CITY OF ISSAQUAH
DEVELOPMENT SERVICES DEPARTMENT
URBAN VILLAGE DEVELOPMENT COMMISSION

STAFF REPORT

October 8, 2013

File No.: SDP 13-00003
Project: Issaquah Highlands
Site Development Permit - Blocks 25-27 (Discovery West)

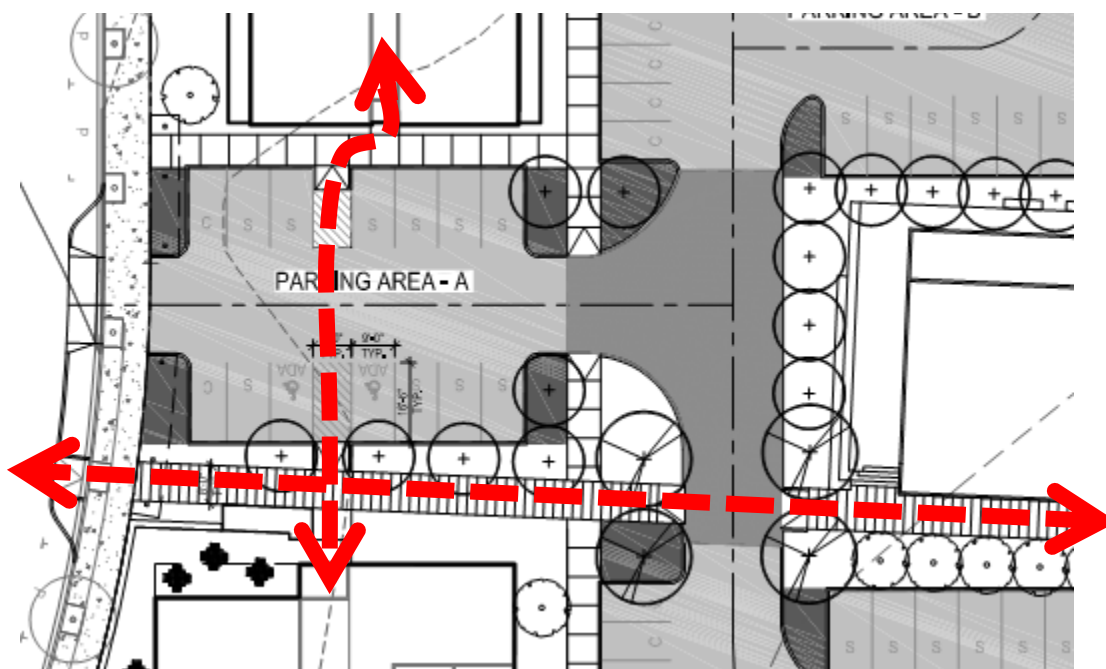
From north to south, users can opt to walk or bike along either the multi-use trails to the east, or by using the public sidewalk along 8th Avenue NE. From east to west, three primary routes are provided: the sidewalk along Discovery Drive NE; the Neighborhood Trail that bisects the project and connects 8th Avenue NE to the pedestrian bridge; and, the southernmost sidewalk that connects from 8th Ave NE to the easterly trails. In total, the project proposes a variety of routes for users to reach destinations both within the project, and elsewhere within Issaquah Highlands.

To be pedestrian friendly, sidewalk and trails must be pleasant, direct, easy to find. This will result in some segments being straightened out or slightly modified (e.g. the southernmost sidewalk that connects 8th Avenue NE to the trail at the southeastern corner of the Property). Additionally, where pedestrians interface with vehicular routes where pedestrian facilities cross driveways and parking lots, treatments shall be used which clearly delineate the pedestrian priority and enhance pedestrian safety. To improve the pedestrian orientation, where pedestrian ways intersect with vehicular routes, including streets and alleys, treatments shall be used *at the locations shown below* which clearly delineate the pedestrian priority and enhance pedestrian safety. **[Condition 10]**

Parking Area A pedestrian access route

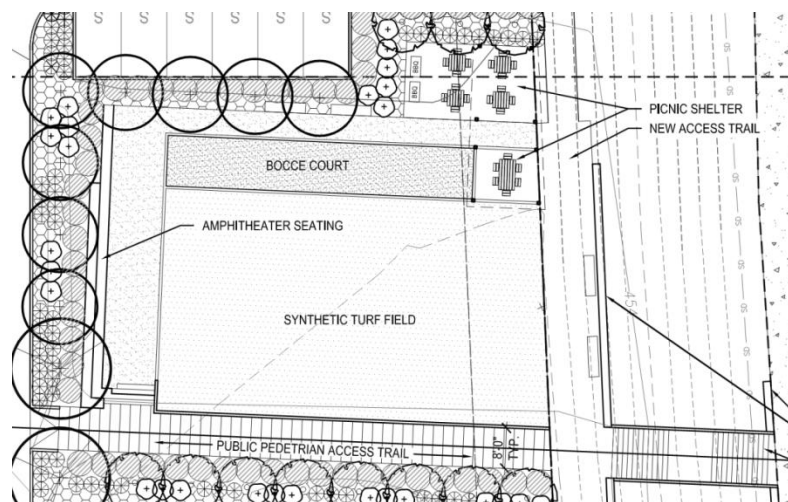
Given the higher volume of pedestrian and vehicular activity that is expected within and around the parking lot, additional pedestrian friendly design elements are warranted to ensure a safe, functional and aesthetically interesting environment.

Central gathering area (Sht L-102 excerpt)

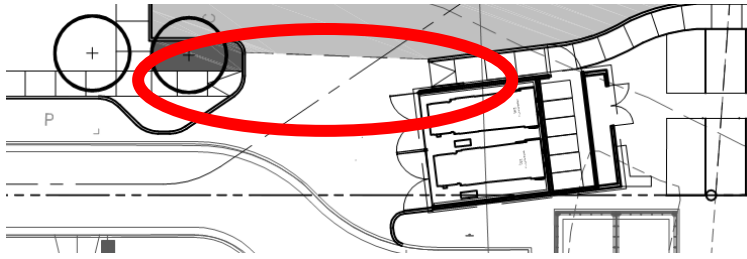
As mentioned above in Principle #3, a variety of indoor and outdoor spaces has been proposed. The project proposes to create a 'sociable public realm' through the use of a sidewalk and trail environment that is attractive, safe, inviting, and pedestrian friendly. The gathering area provided in the central portion of the project is appropriate given the Traditional Townscape Neighborhood type. Features of the gathering area located directly include seatwalls, picnic shelter, barbecues, bocce court, and turf field. Additionally, the gathering area is provided directly off of the east/west trail making it easily accessible for pedestrians. The open turf field will allow for a variety of play opportunities for people of all ages.

North Site Access Points from 8th Avenue NE

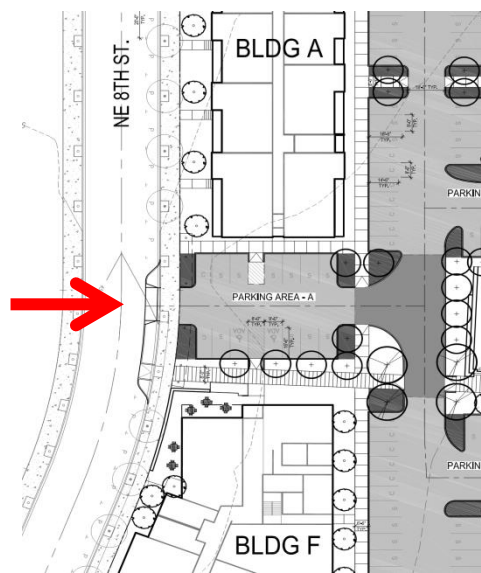
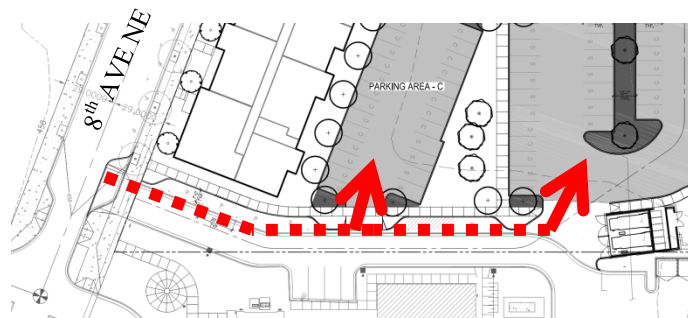
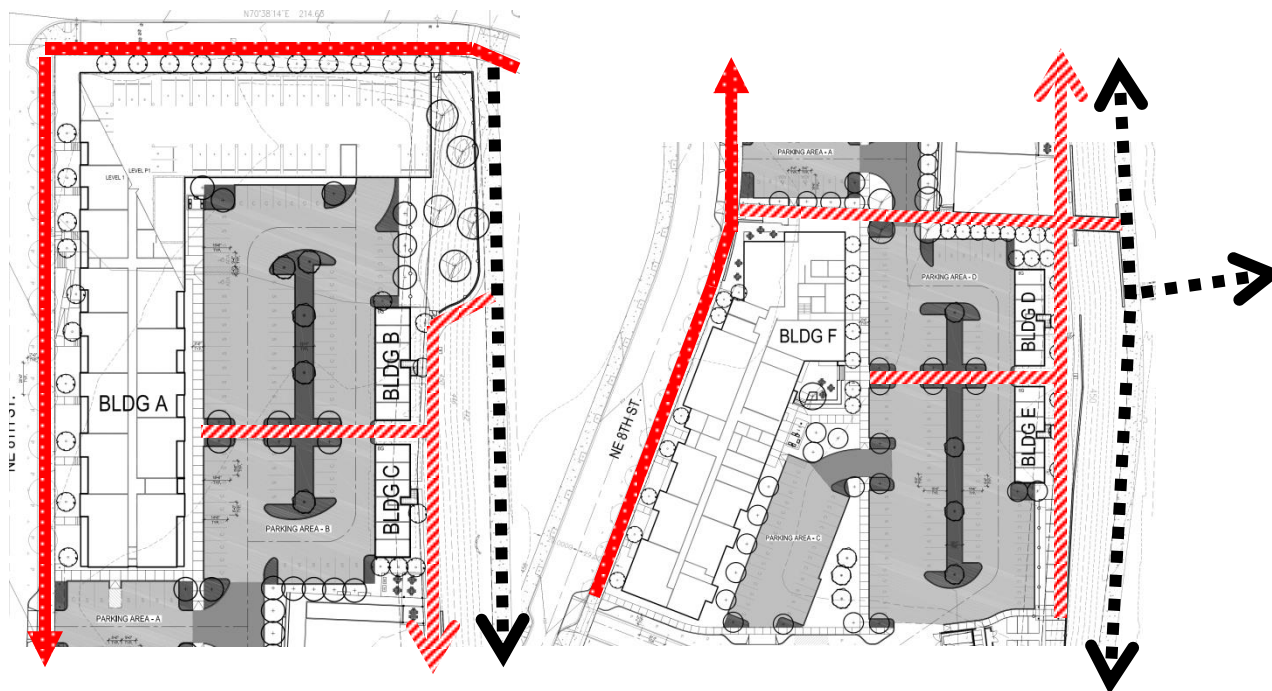
The proposed northerly driveway includes a new curb bulb-out and a pedestrian ramp. The alignment of the east/west trail and the required 8th Avenue NE pedestrian crossing shall be evaluated during the Utility Permit review to determine if they should align or can be offset.

The proposed southerly driveway will be shared with the existing uses on Block 28. That driveway is close to the intersection of Blakely and 8th Avenue NE and must be signed for “right-out” only. [Condition 24] In addition, the plans show an extension of the existing curb-bulb so that the new driveway intersects the edge of the northbound travel lane and not the curbline. The existing configuration may be preferred as it would promote a right-turn only exit from the driveway and give drivers some additional room for maneuvering and should be retained. Additional review of the driveway and curb-bulb is needed to ensure that traffic and emergency vehicle turning movements can be accommodated. This will be completed during the review of the Utility Permit.

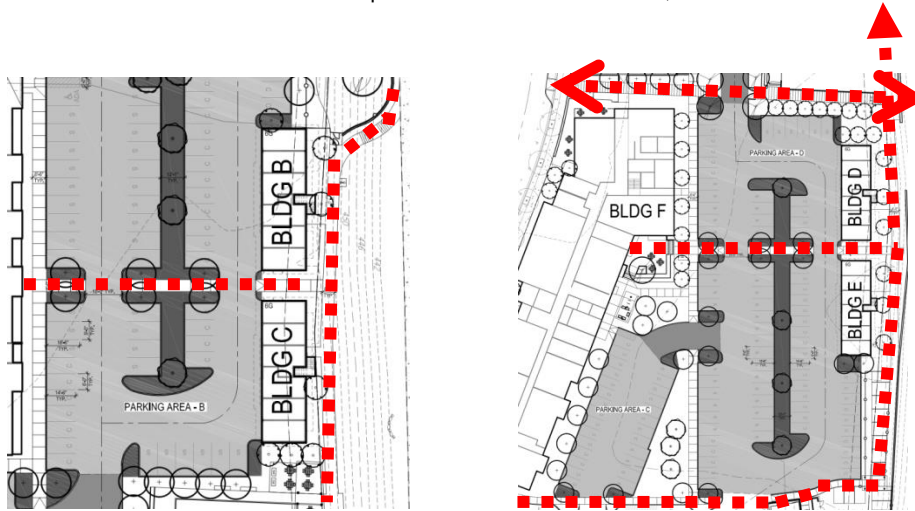
Access and equipment associated with wet and dry utilities are a necessary part of a functioning community. However, their presence does not enhance the overall project character and objectives. Screening and location can reduce the impact of these necessary elements.

Both mechanical equipment on the ground and equipment on the roof should be screened once the appropriate location is identified. Roof equipment should be screened both for views from the ground but also views from above consistent with minimizing their visual presence. The intent is to screen the mechanical equipment from the buildings' upper floors or buildings which are at higher elevations. Study of the sightlines is necessary to determine what type of screening is necessary. However, as buildings on the parcels east of the project are much taller, roof equipment will likely need screening from above. **[Condition 46]**

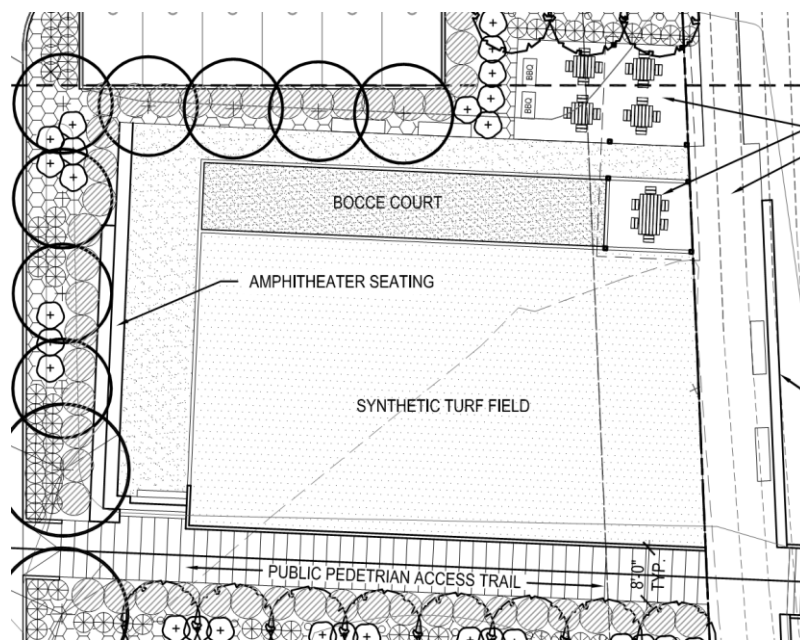
In order to provide intuitive route finding through the site and to highlight the presence of other nearby trails (e.g. the multi-purpose trails and pedestrian bridge located east of the Property), wayfinding signage should be provided at various locations throughout the project.
